1 Q. **Reference: Application, Capital Programs and Projects, Upgrade PLX Metering System (2026–**
2 **2028) – Labrador East**

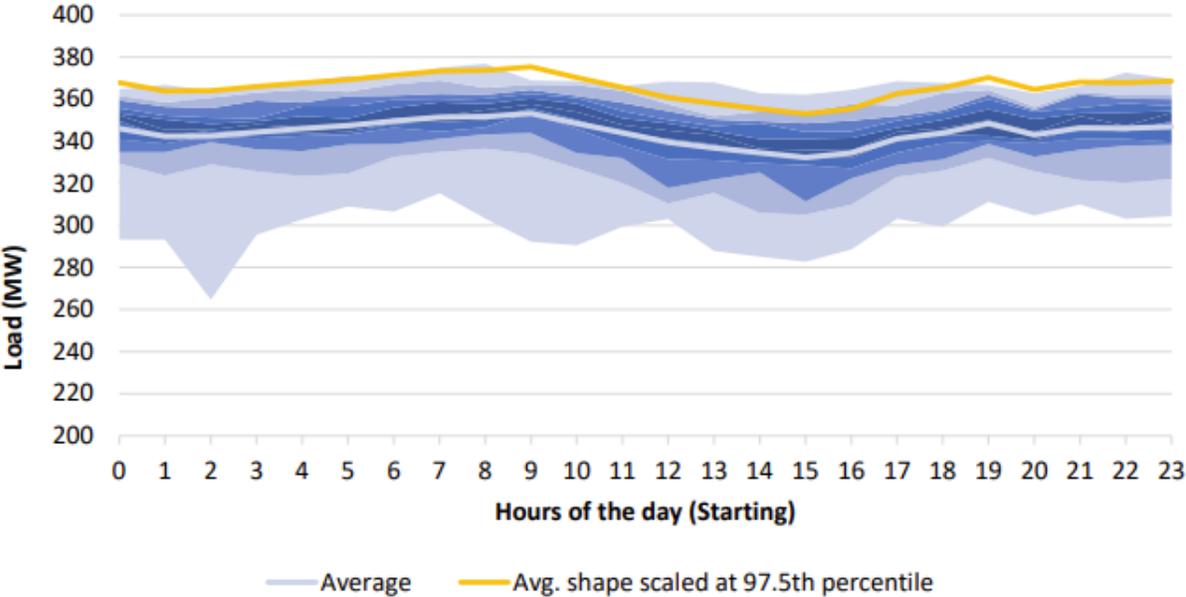
14 For example, a higher rate during evening peak (5:00 p.m. to 8:00 p.m.) would give customers a
15 price signal to shift some of that electricity consumption into the hours before and after this
16 time window. The following graph of the Labrador Interconnected System’s load shape was
17 provided in the referenced study:

1 As noted by Dunsky:

2 *The results show that LAB system nearly as a perfectly flat load shape. This would be*
3 *expected to greatly limit measures with bounce-back or pre-charge effects as they risk*
4 *creating new peaks by shifting load from one hour to another.*

5 Put simply, an investment in AMI for dynamic rates on the Labrador Interconnected System
6 would be more costly than Hydro’s proposal **and** risk creating a new system peak that is less
7 efficient than the current “nearly perfectly flat” load shape.
